RE: **EERA Comments and Recommendations on Scoping Process**
Xcel Energy Alexandria to Big Oaks 345 kV Transmission Project
Docket No. E002, ET2, ET10, E015, E017/TL-23-159
Docket No. E017, ET2, E002, ET10, E015/CN-22-538

ENERGY ENVIRONMENTAL REVIEW AND ANALYSIS COMMENTS AND RECOMMENDATIONS

ALEXANDRIA TO BIG OAKS 345 kV TRANSMISSION PROJECT DOCKET NOS. E017, ET2, E002, ET10, E015/CN-22-538 AND E002, ET2, ET10, E015, E017/TL-23-159

Figure 2a
MnDR Mississippi Crossing Option 1
 ALEXANDRIA TO BIG OAKS
 MISO LRTP-2

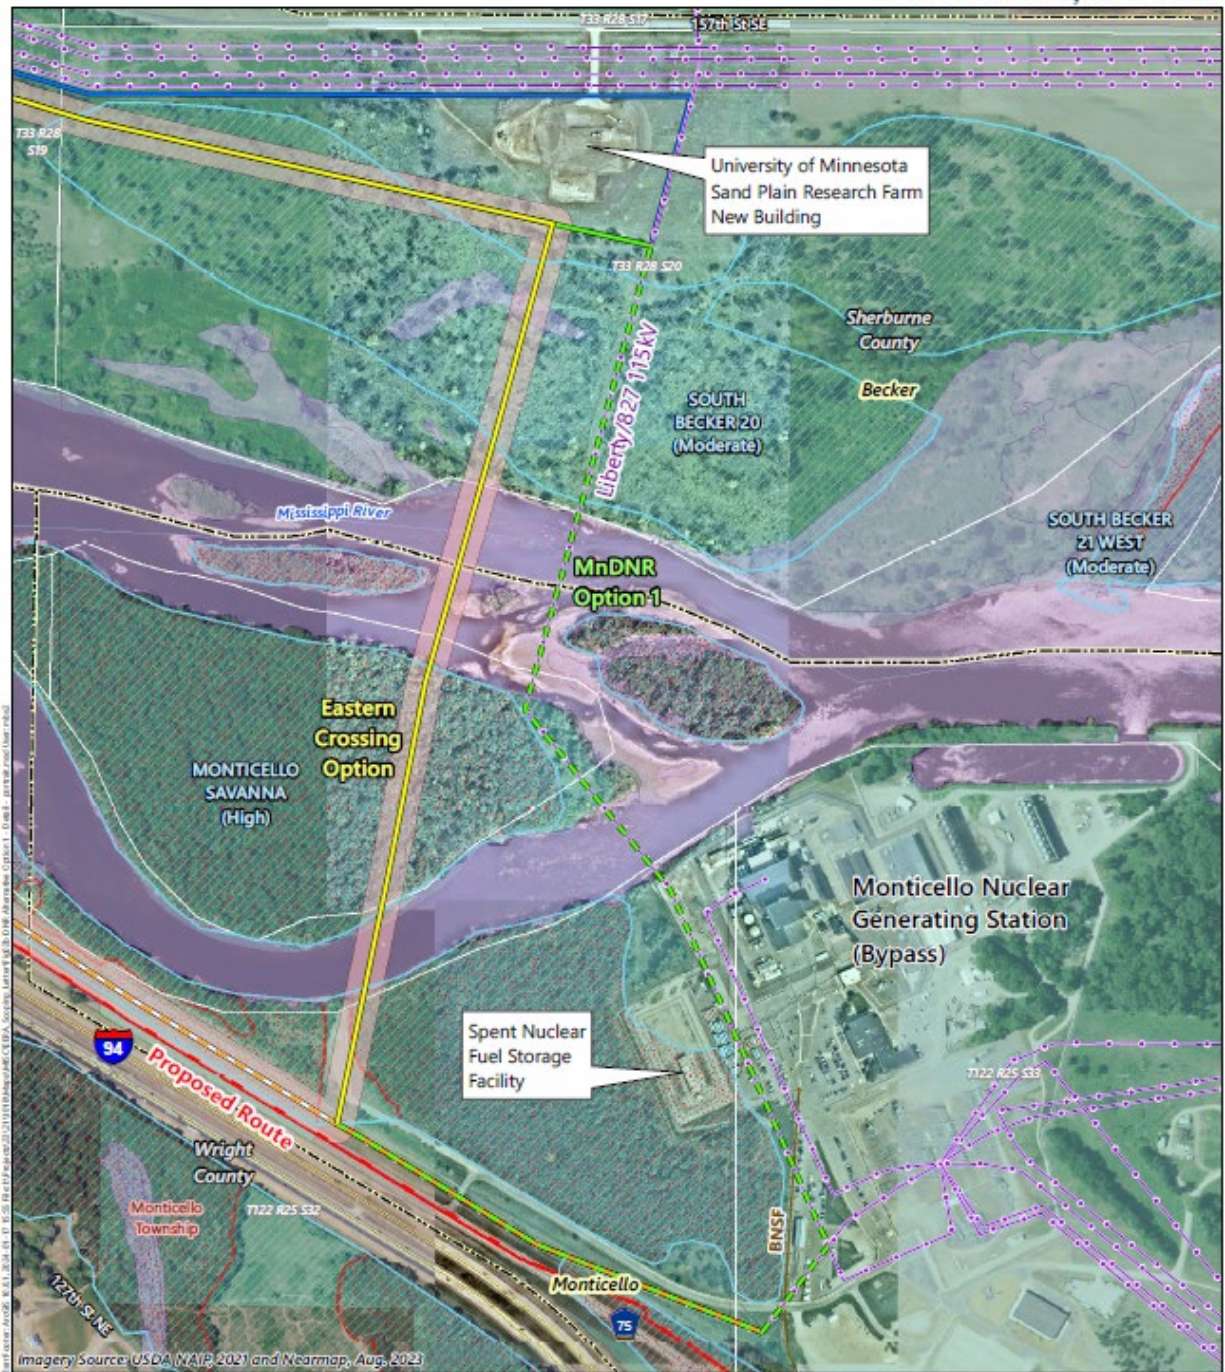
- Xcel Energy proposes this route be modified to shift south after crossing the river to avoid a building that is currently under construction and to provide adequate clearance between the proposed and existing transmission lines in the area (Attachment A, Figures 2a and 2b).
